| Title - Sujet Audio Visual Systems/Carling Campus | |
| Solicitation No. - N° de l'invitation W8474-17CA17/A | Amendment No. - N° modif. 005 |

Amendment # 5 is issued to answer a potential bidders questions and to extend the bid closing date to June 29, 2018.

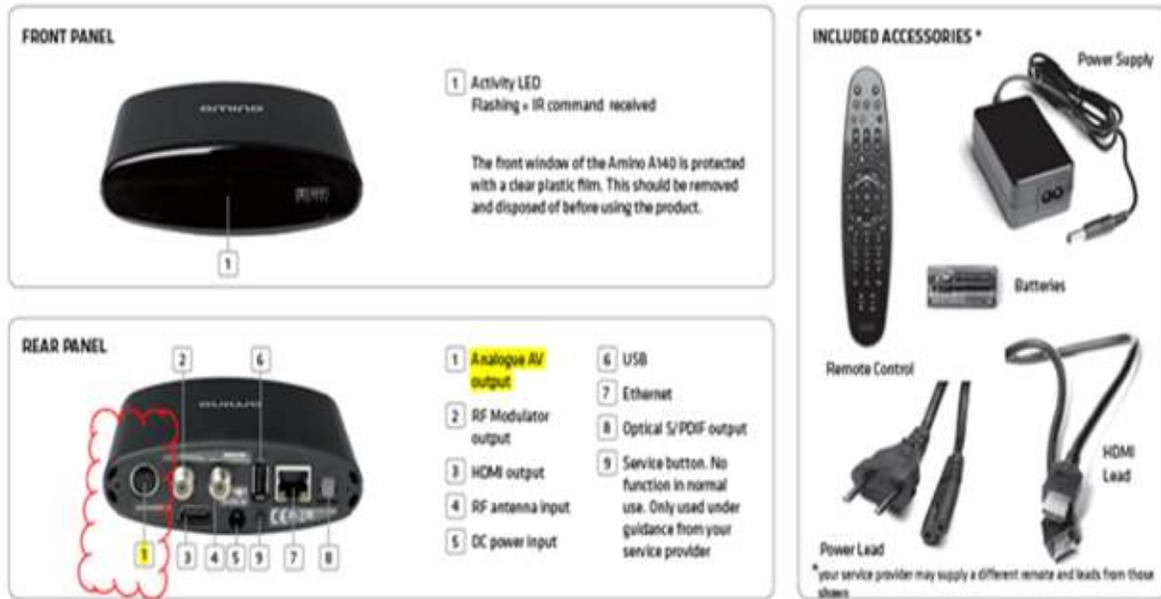
Based on the user guide for the Amino A140, the audio is taken out of a 10pin Din connector.
We will go with assumption that you are providing a box with standard RCA output for analog audio?

The audio from the Amino A140 set-top boxes will be carried through HDMI. The IPTV audio may be de-embedded from the HDMI signal as per drawing 17-CAMPUS-5E3-101.
Canada will not provide boxes with standard RCA output.
